# Engineering Work Sheet – Fossil & Hydro

| Project: Possum Point Ash Pond C Outlet Box Stop Log Sealing | Document Type: ☐ Calculation ☑ Sketch ☐ Other | Sheet No. — of — |
| | Doc. No.: PP-CLC04162015-SSK-001 | Rev. No. 1 (Revised Wall Thick. & Sika Fuko) |
| Subject: Plan at Existing Ash Pond Outlet Box | Prepared By: C. Cole | Date: 4-21-2015 |

SECTION A-A (SSK-001)

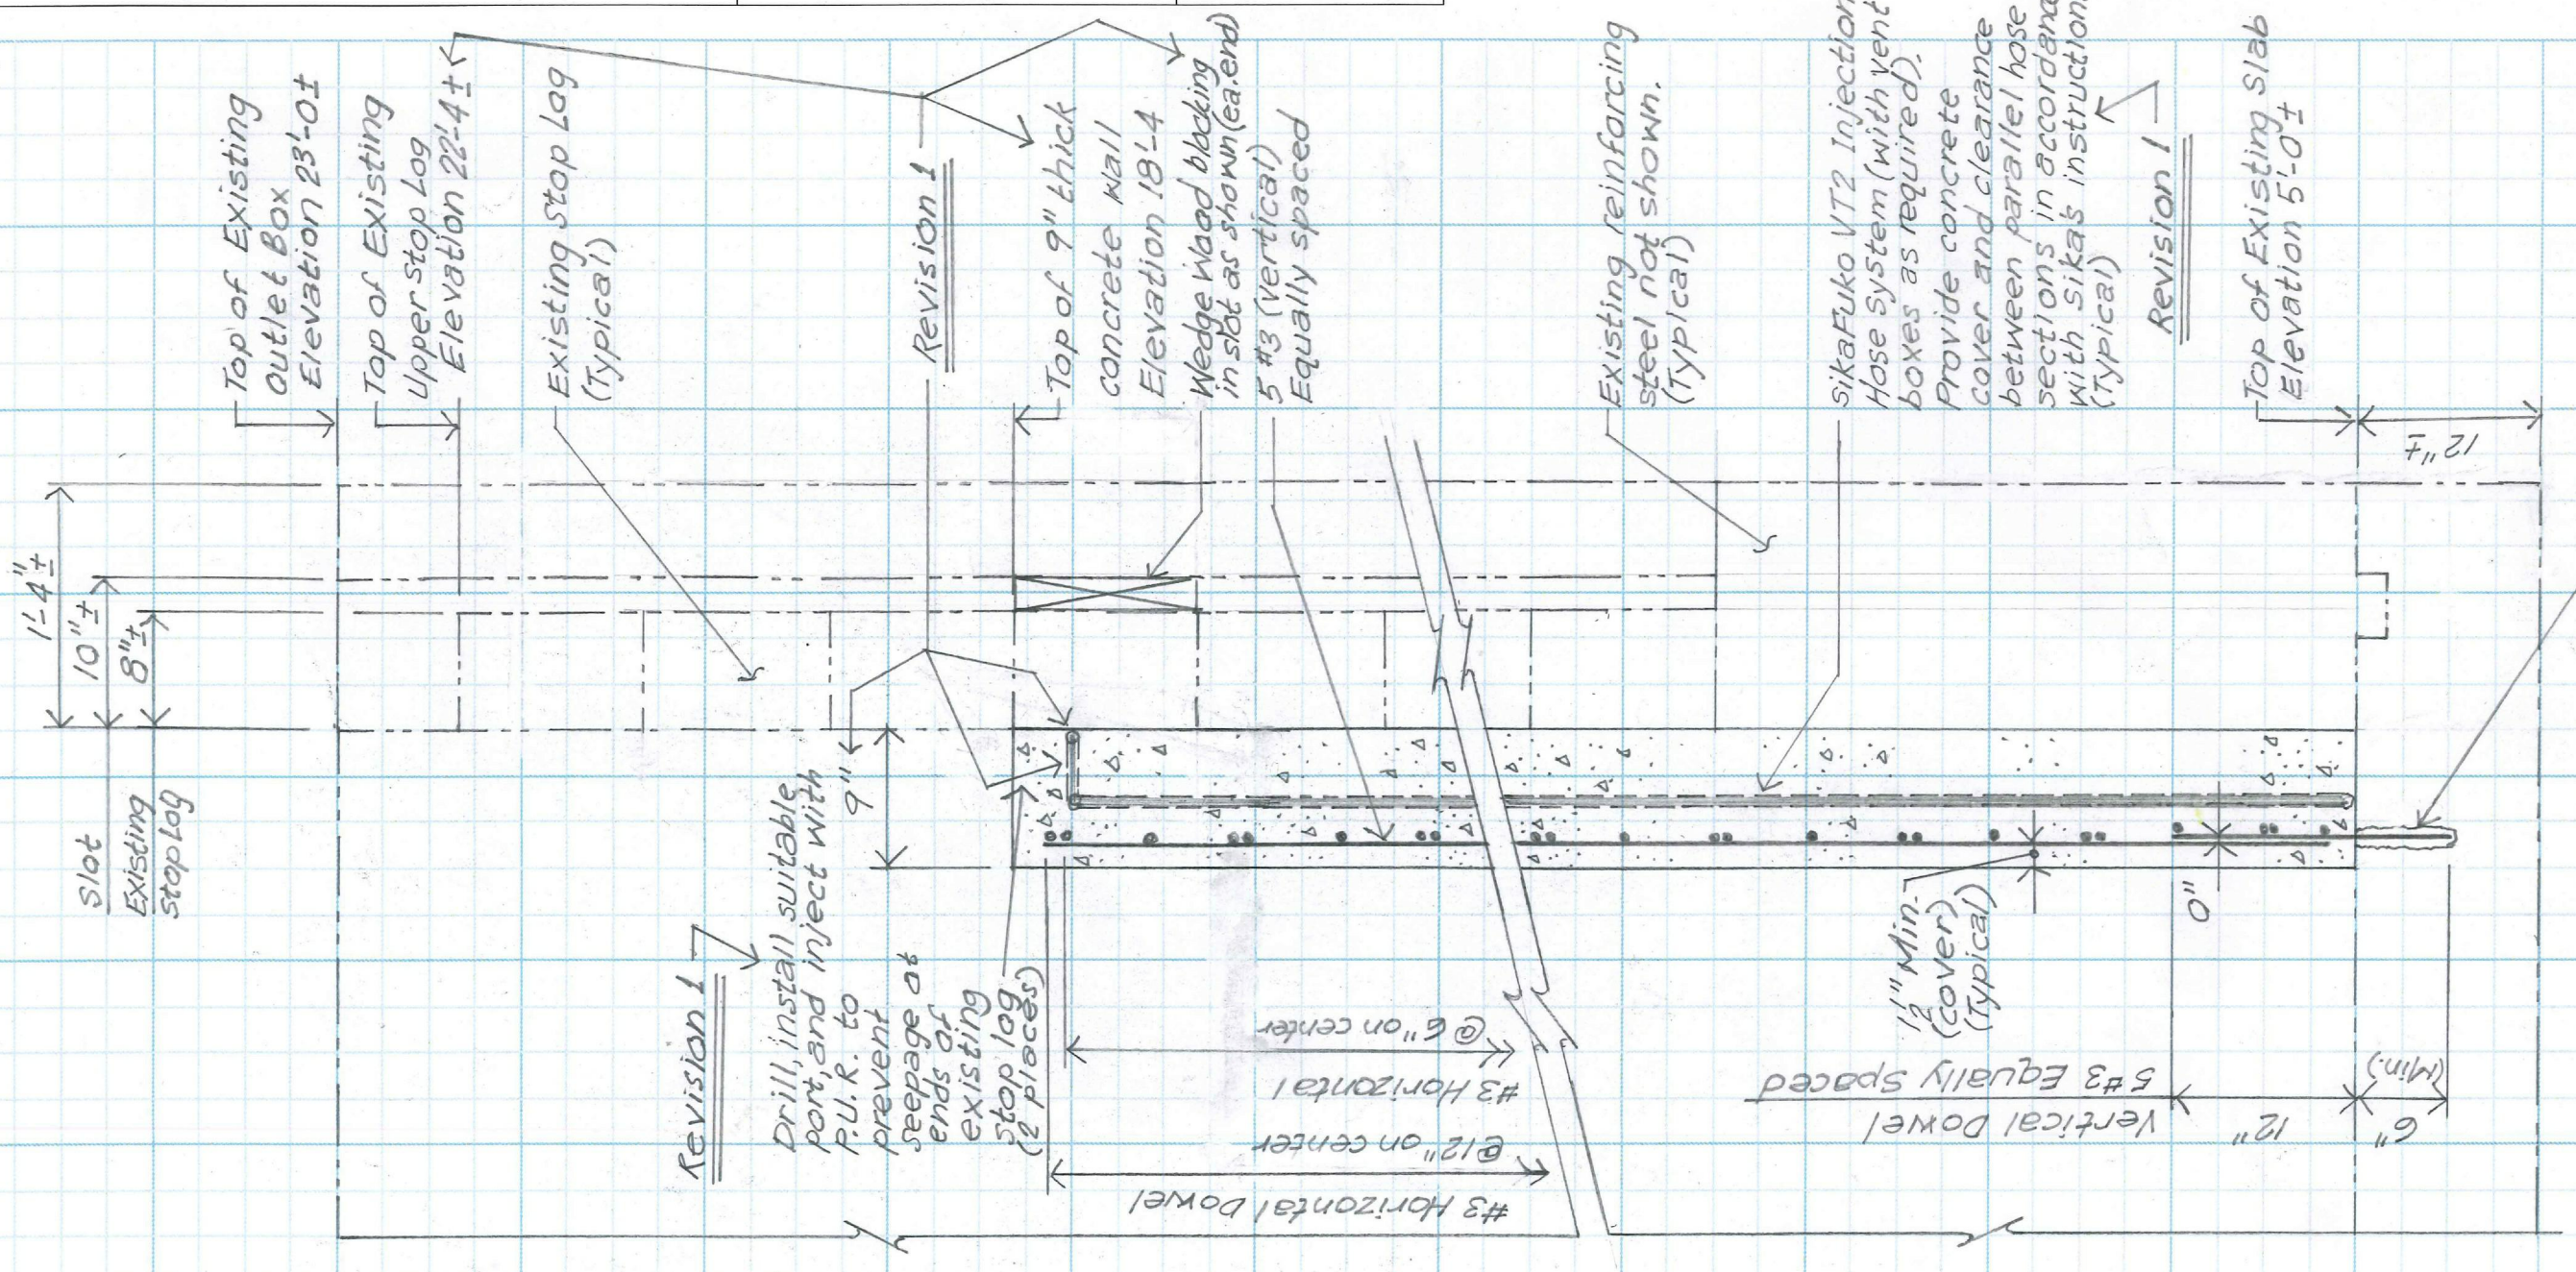
| | Doc. No. PP-CLC041620IS-SSK-002 | Rev. No. 1 (Revised Top of Wall, Thickness & Sika Fuko) |

DETAIL 1 (SSK-001)
SCALE: 1" = 1'-0"

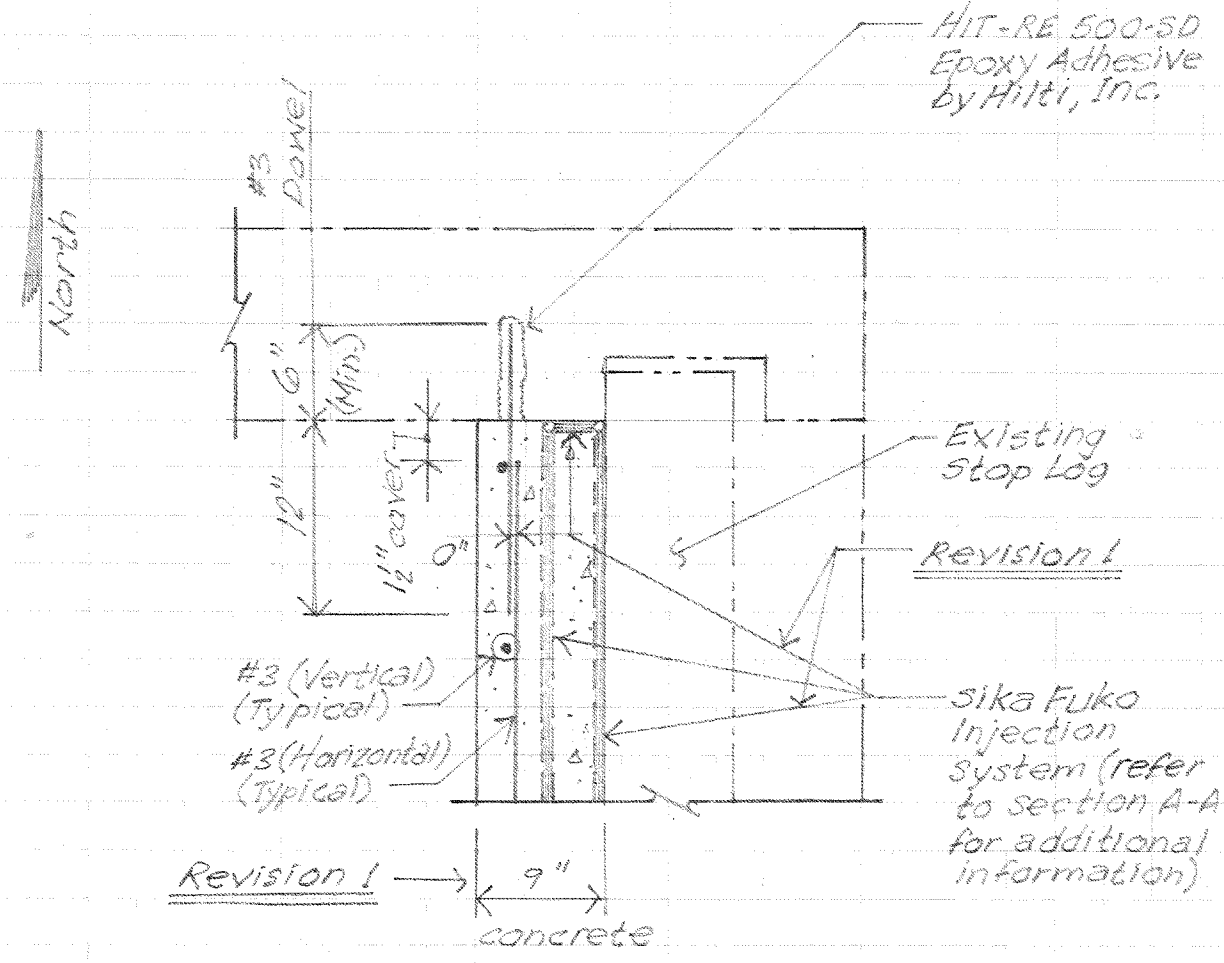
| | Doc. No. PP-CLC041620 15-SSK-003 | Rev. No. 1 (Revised Wall Thick & Sika Fuko) |

5. Sika Fuko Injection System shall be installed and used in accordance with instructions and specifications by Sika Corporation, Lyndhurst, NJ. Inject Sika Fuko VT2 Injection Hose VT2 with Sika 306 Injection Resin 28 days (minimum) after placing concrete. Revision 1
6. Drilling, mixing, placing, and setting (curing) of HIT-RE 500 SD Epoxy Adhesive shall be in accordance with Hilti, Inc., (Tulsa, OK) instructions.
7. Submit concrete mix design for review.
